TRIDENT SEAFOODS CORPORATION

RE: Draft Alaska General Permit Number AKG521000 Comments

Please find Trident Seafoods Corporation's (Trident) comments on the Alaska Department of Environmental Conservation (ADEC) draft Alaska General Permit No. AKG521000 below. Trident wishes to provide comments on several issues we believe need to be revised prior to finalization of the permit.

Figure 1. Map of Surficial Seafloor Seafood Waste Observed in the Cordova Study Area during 2018 Survey (INSPIRE 2019)

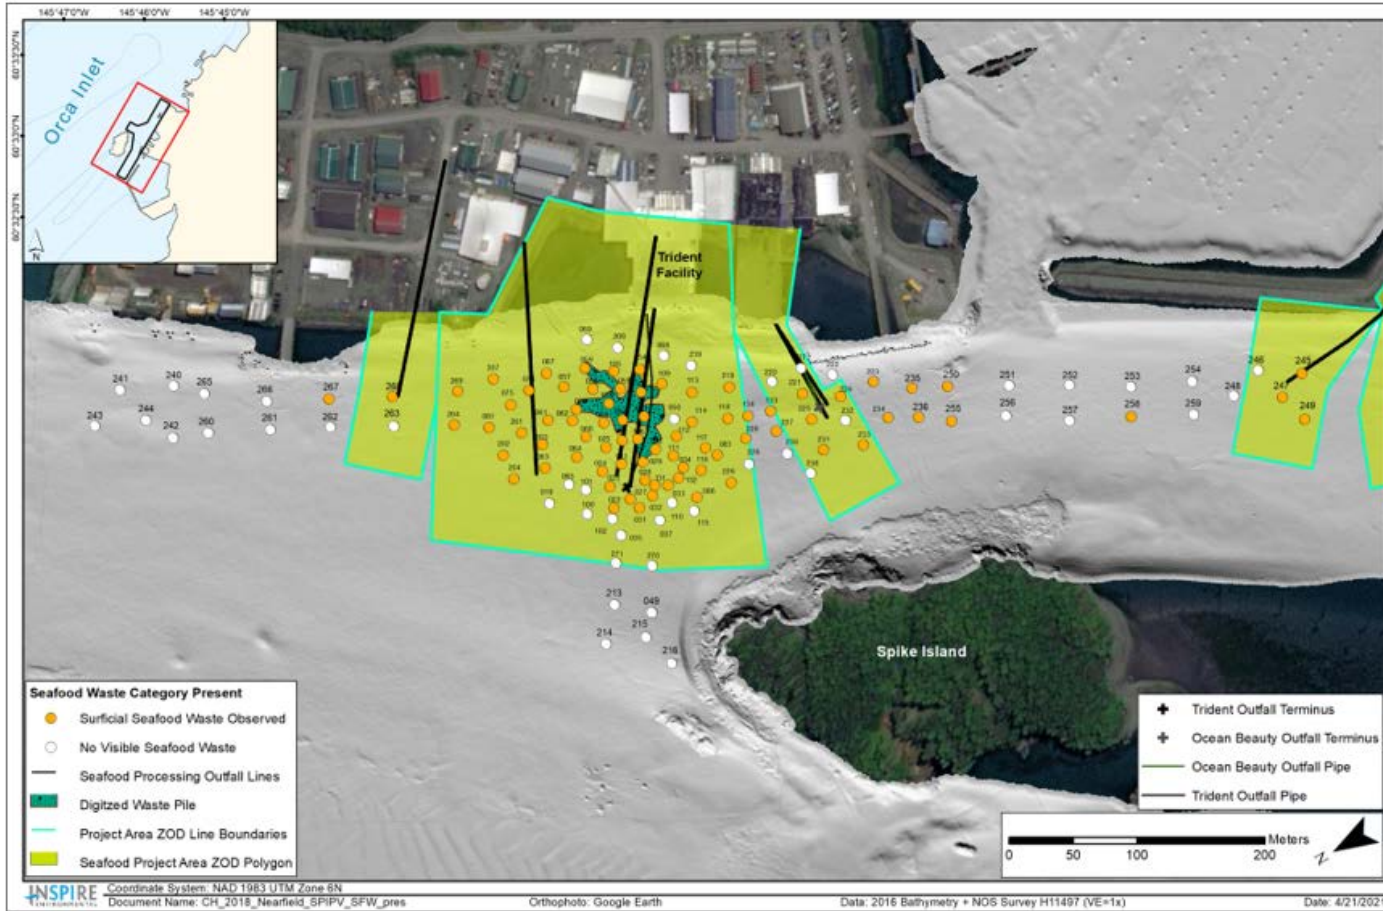
In addition, Trident would like to note that with varying thickness detection levels inside and outside of the PAZOD, seafood waste observed outside of the PAZOD could be counted towards a permittee’s Zone of Deposit, but if a permittee applied to expand a PAZOD to extend over that area, the same seafood waste could no longer be included in the ZOD if it is below the 1/2” thickness threshold. This does not make logical sense as it creates two

inconsistent categories of deposits. Trident expects that this quandary is likely to occur, as shown by the stations with surficial waste observed outside of the publicly noticed PAZODs in the Cordova area in attached Figure 1.

Figure 2: Cordova North Digitized Waste Pile Map Comparison

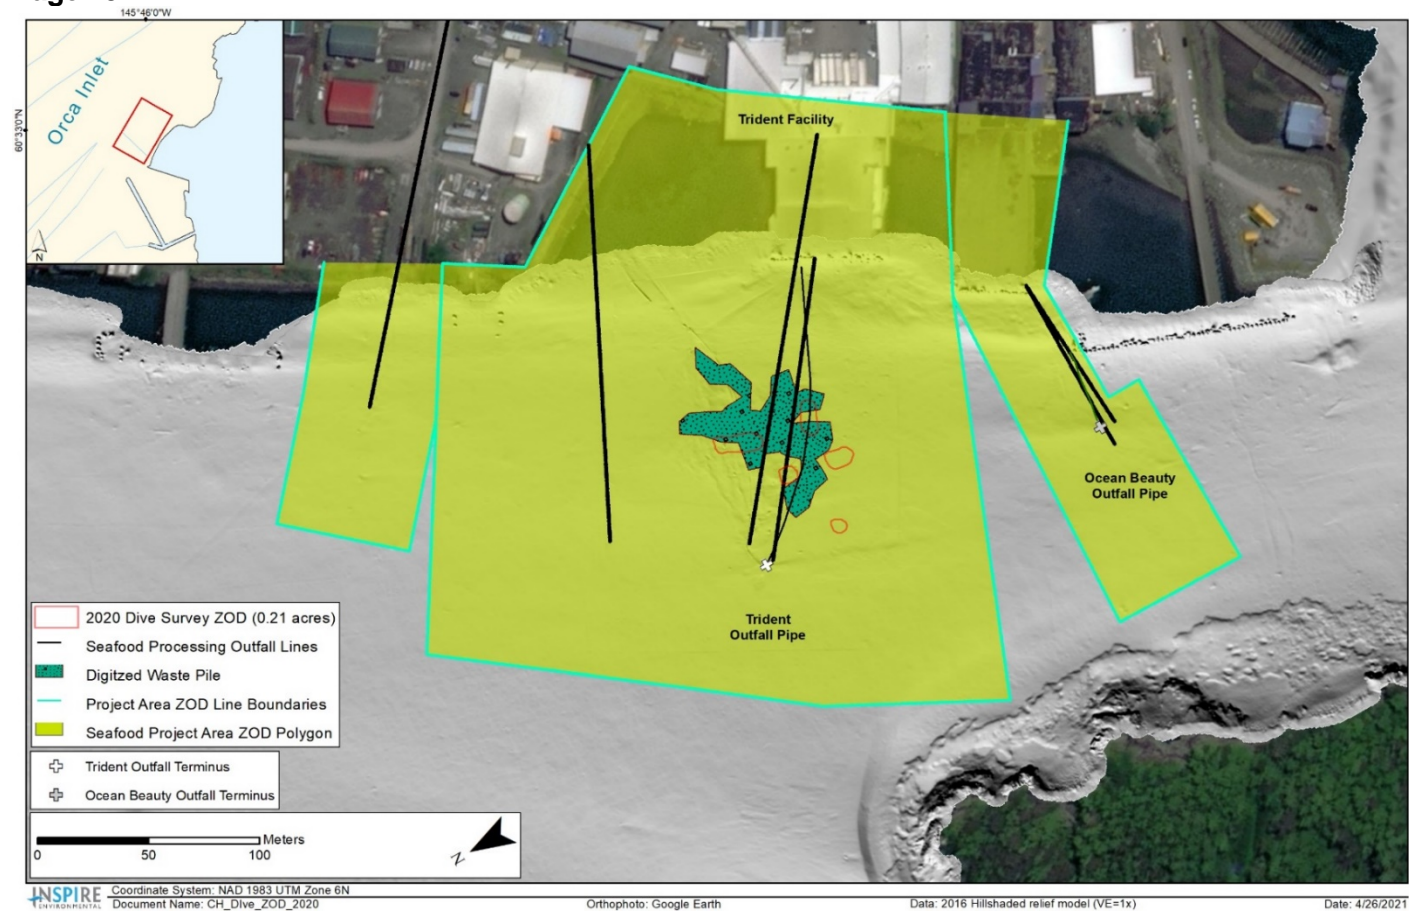
Trident has compared the shapefiles from the referenced seafloor surveys to the digitized waste piles in the mapped Project Area Zone of Deposit publicly noticed maps. In areas with greater than zero Zone of Deposit, the published maps do not appear to correlate with the most recent seafloor survey data, as indicated in the file's metadata. Please see attached Figure 2 for Cordova North Digitized Waste Pile Map Comparison, attached Figure 3 for Cordova South Digitized Waste Pile Comparison, attached Figure 4 for Ketchikan Digitized Waste Pile Map Comparison, and attached Figure 5 for Wrangell Digitized Waste Pile Map Comparison. Please correct the published Digitized Waste Pile objects to match Trident's most recently submitted seafloor survey ZOD data or provide the data source for the digitized waste piles on the publicly noticed maps.
